Entergy Nuclear Operations, Inc.
Palisades Nuclear Plant
27780 Blue Star Memorial Highway
Covert, MI 49043-9530
Tel 269 764 2000

PNP 2013-075

SUBJECT: Response to Request for Additional Information – License Amendment
Request to Adopt NFPA 805 Performance-Based Standard for Fire
Protection for Light Water Reactors

RESPONSE TO REQUEST FOR ADDITIONAL INFORMATION REGARDING LICENSE AMENDMENT REQUEST TO ADOPT NFPA 805 PERFORMANCE-BASED STANDARD FOR FIRE PROTECTION FOR LIGHT WATER REACTORS

Figure 1 - PNP Non-Licensed Operator Training Flow Chart

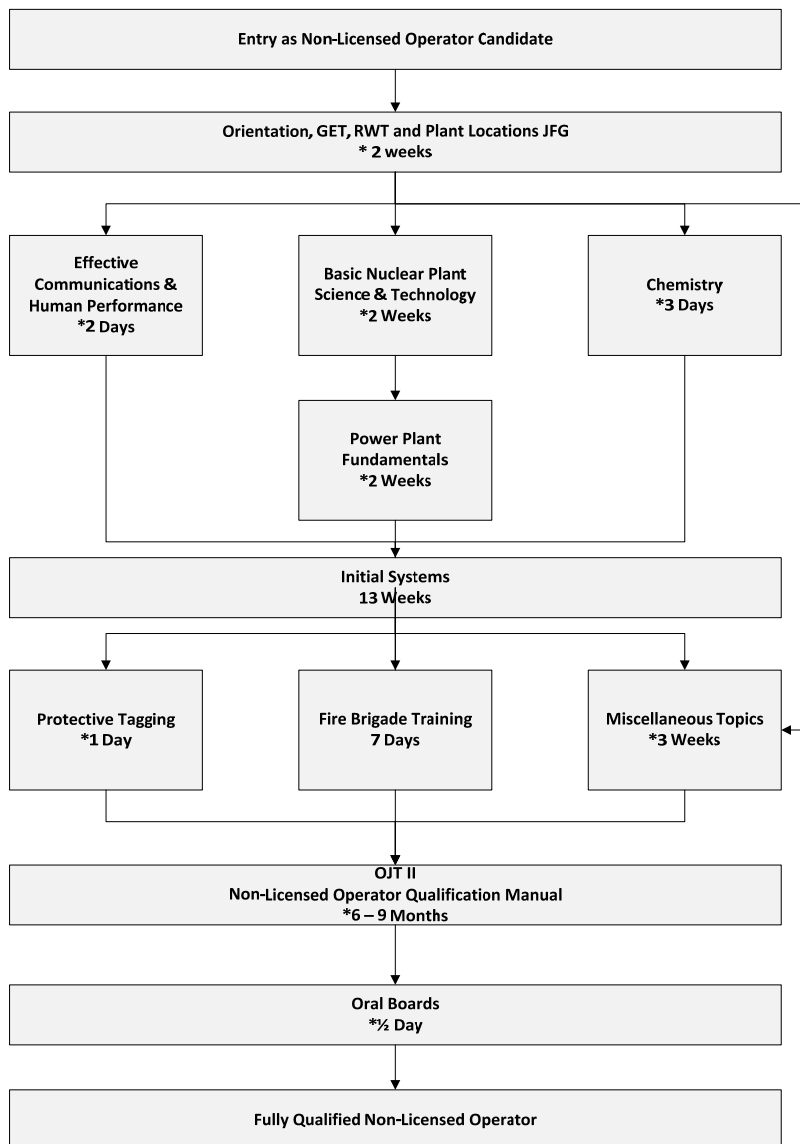
NFPA 805, Section 3.4.1(c) specifically requires the fire brigade leader and two members to have sufficient training and knowledge of nuclear safety systems to understand the effects of fire and fire suppressants on nuclear safety performance criteria. In Regulatory Guide (RG) 1.189, "Fire Protection for Nuclear Power Plants", Rev. 2, the staff has acknowledged the following example for the fire brigade leader as sufficient : "The brigade leader and at least two brigade members should have sufficient training in or knowledge of plant systems to understand the effects of fire and fire suppressants on safe-shutdown capability. The brigade leader should be competent to assess the potential safety consequences of a fire and advise control room personnel. Such competence by the brigade leader may be evidenced by possession of an operator's license or equivalent knowledge of plant systems."

At PNP each fire brigade shift consists of a fire brigade leader and a minimum of four fire brigade members. The fire brigade leader is a qualified Nuclear Plant Operator (NPO) with Plant operating experience/seniority that supports the individual's position as a brigade leader. A minimum of four other fire brigade members are also qualified NPOs. Reference procedure EN-OP-115, Attachment 9.6 for shift staffing requirements. NPOs in training may also be assigned to a shift and function as a brigade member as part of their On the Job Training (OJT) program.

A Nuclear Plant Operator is required to qualify under the Non-Licensed Operator Training program. This training addresses multiple areas of study including; communication, nuclear technology, power plant fundamentals, plant systems, and fire brigade training. In addition to study, the qualification requirements include extensive OJT to reinforce class room skills and establish operating knowledge and skills in such areas as operating equipment, procedure use and control room communications. Details of the NPO training qualification are provided in a site-specific course plan titled "Palisades Non-Licensed Operator Course Plan". This plan is revised as needed to ensure NPO personnel are trained on plant systems and components and are trained to the latest information available to maintain their knowledge and abilities. A flow chart from the course plan of the Non-Licensed Operator Training program is provided in Figure 1.

Figure 1 is obtained from “Palisades Non-Licensed Operator Course Plan” which provides the details associated with this flow chart.
